6 March 2012

**Our Ref: 120228/S1**

**RE: ORION NZ LIMITED**  
**218 MANCHESTER STREET, CHRISTCHURCH**  
**STRUCTURAL CONDITION OF THE CAR PARK BUILDING**

Plan of damage locations

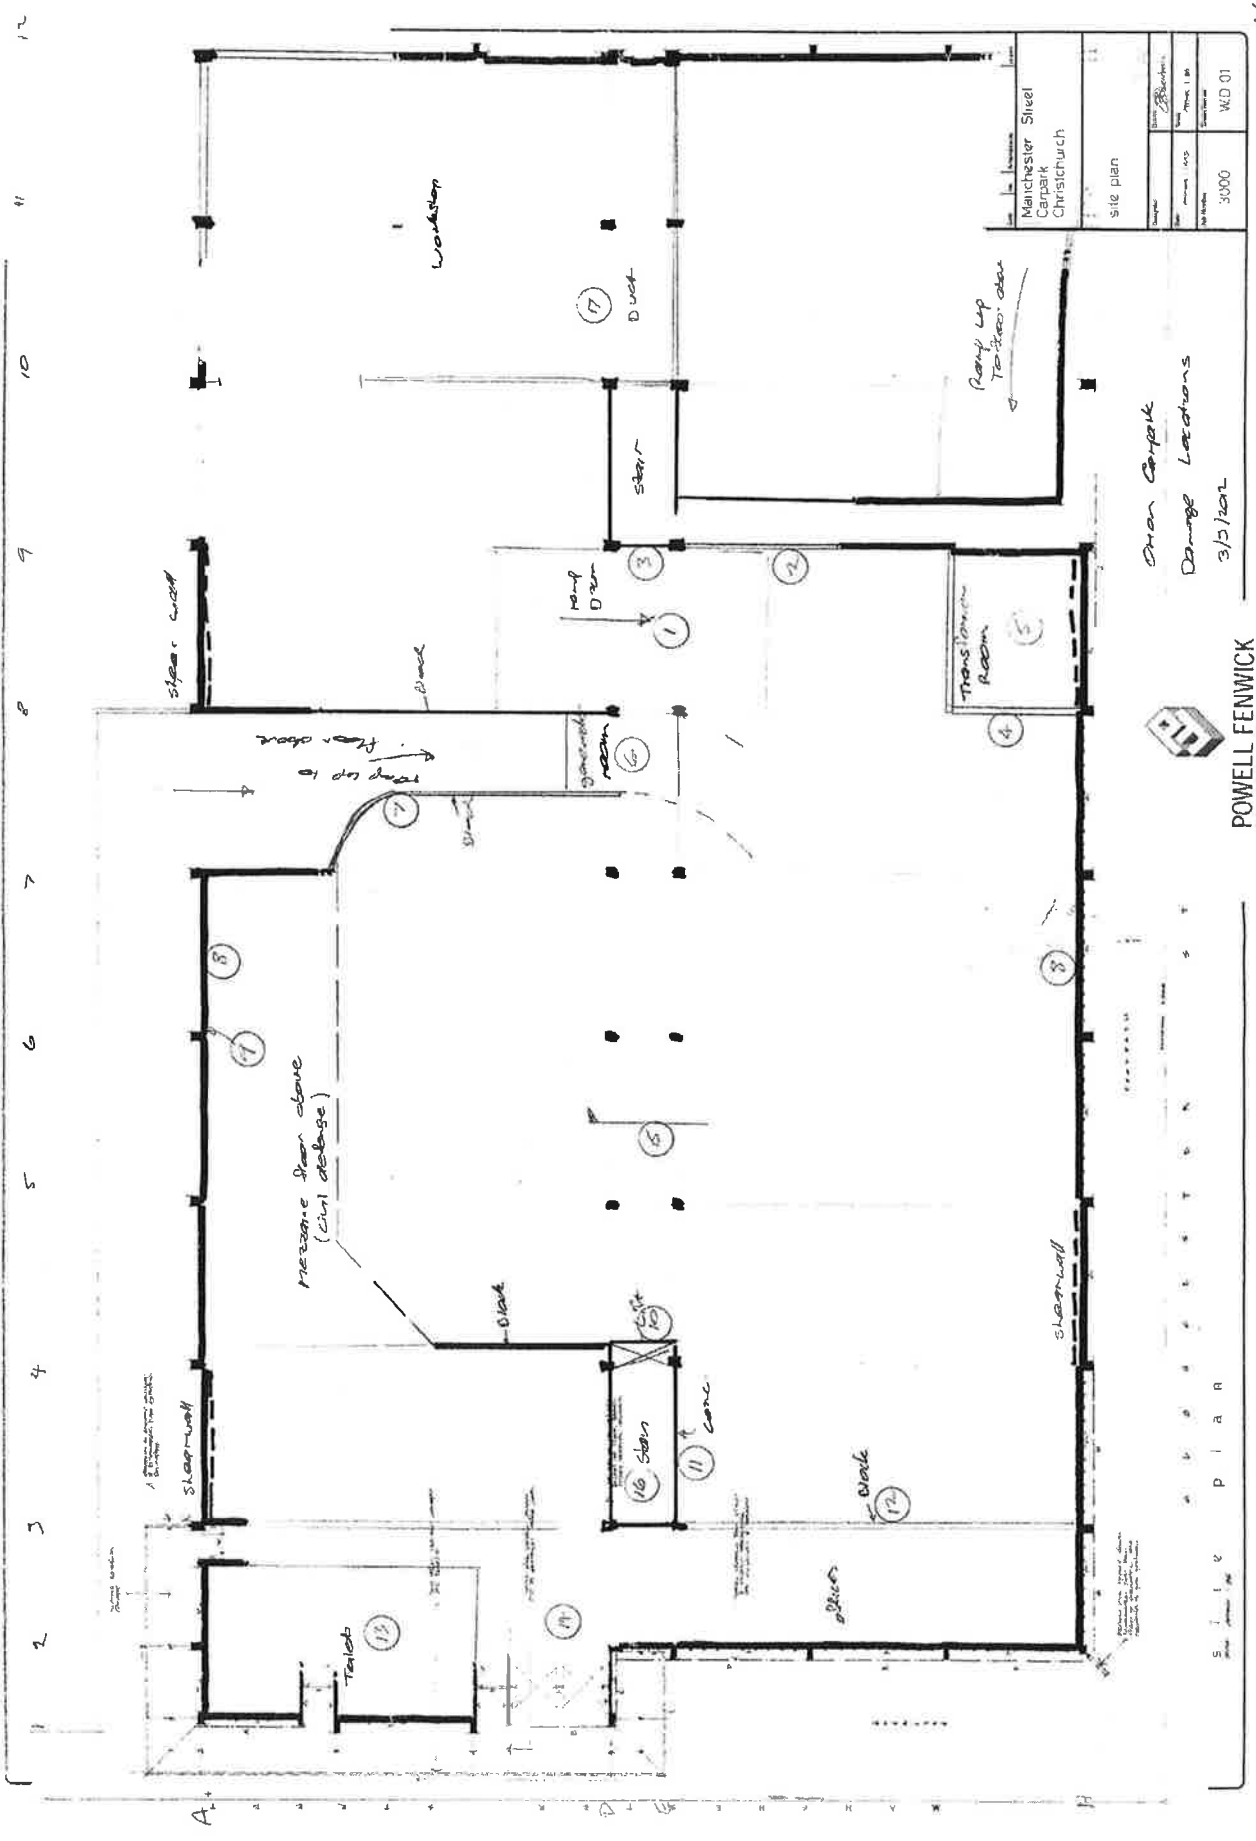
Refer to the attached marked up plan for location of the damage.

1. North side ramp from the ground to the upper level has separated from the upper floor. Cracking to the north ramp ground floor midpoint between the supports.

2. Gap formed between the non load bearing concrete masonry walls and the beams above.
3. Shear cracking to the insitu concrete wall adjacent to the entry ramp.

4. Step cracking to the unreinforced masonry wall surrounding the transformers plus 6 mm translation of bricks.
5. Cracking to the ground floor where the centre of the floor has risen.

6. The ramp support beam visible in the generator room has significant cracking to the end supports. The beam has subsequently been propped with SHS steel columns.

7. Step cracking and translation of the masonry wall that forms the side of the ramp to the floor above. This wall is a double skin 90 mm concrete masonry columns with 200 mm masonry bond beams at various levels. There is also damage where the wall intersects the columns.

8. Vertical cracking at the centre of the exterior low level insitu concrete walls, typically midway between columns in numerous locations. (only some locations are indicated on the plan)

9. Spalling of column concrete where it intersects the short walls noted in 9 above.
10. Shear cracking to the concrete wall.
11. Vertical cracking to the concrete walls.

12. Settlement of the floor slab has created a 25-30 mm gap between the beam and the masonry wall below.
13. Minor cracking to the plasterboard walls in the amenities area. Delaminating of the plaster coating to the columns in the toilets.

14. Cracking to the concrete walls in the entry foyer.
15. Step in the floor at the intersection of the centre concrete strip and the main floor. This central strip is the main foundation support for the centre columns and as such is supported on piles. Orion staff have advised that the floor falls in this area is greater than prior to the earthquake. It is not possible to confirm this however the level change indicates that there has been movement in the floor.

16. Extensive diagonal shear cracking to the concrete wall in the north south direction and minor cracking to the walls in the east west direction. The landing to the stairs above has cracking to the underside.

17. The electrical duct at the north end of the workshop now has a 5 mm step indicating either the floor has settled or the duct has risen.

- Injection grout the damaged concrete wall at location 3. As this would not have been a designed shear wall, full replacement would not be required to reinstate the building.

- Replace the brick walls surrounding the transformer room. This could be constructed of concrete masonry or timber depending on operational requirements. If this wall cannot be removed for operational reasons, then an external strengthening systems may be required. This could consist of a spray on concrete or perhaps a carbon fibre wrap to stabilize the brick. Alternatively, timber and plywood walls could be constructed each side to support the brickwork.

- Epoxy injection of the cracking to the floor in the transformer room. Ideally, the floor should be replaced however this may not be practical considering the rooms use.

- Re leveling the main floor would require removal of the existing slab and constructing a new one to eliminate the step at location 15. Alternatively a floor topping system such as Sika Monotop could be used to feather the floor to eliminate the steps.

- Additional strengthening plates to the ends of the beam in the generator room to provide lateral support. If the temporary steel posts are to be removed, additional steel beams could be added adjacent to the existing beam. Reinstating the ramp back to the condition prior to the earthquakes would require demolition of most of the ramp and beam and a new ramp constructed.

- The gap between the masonry walls (item 7 and 12) to be filled with a compressible material for example polystyrene as previously. The lateral restraint of these walls will need to be checked.

- Replace the damaged masonry units at location 7, 12 and in the ex civil defense areas. Allowance should be made for separation of these walls from the main structure.

- Epoxy injection of the cracking above 0.2 mm wide in the concrete walls.
- Replacement of the floor slab in the workshop to eliminate the step at the electrical duct or feather the surface with Sika Monotop or equal.
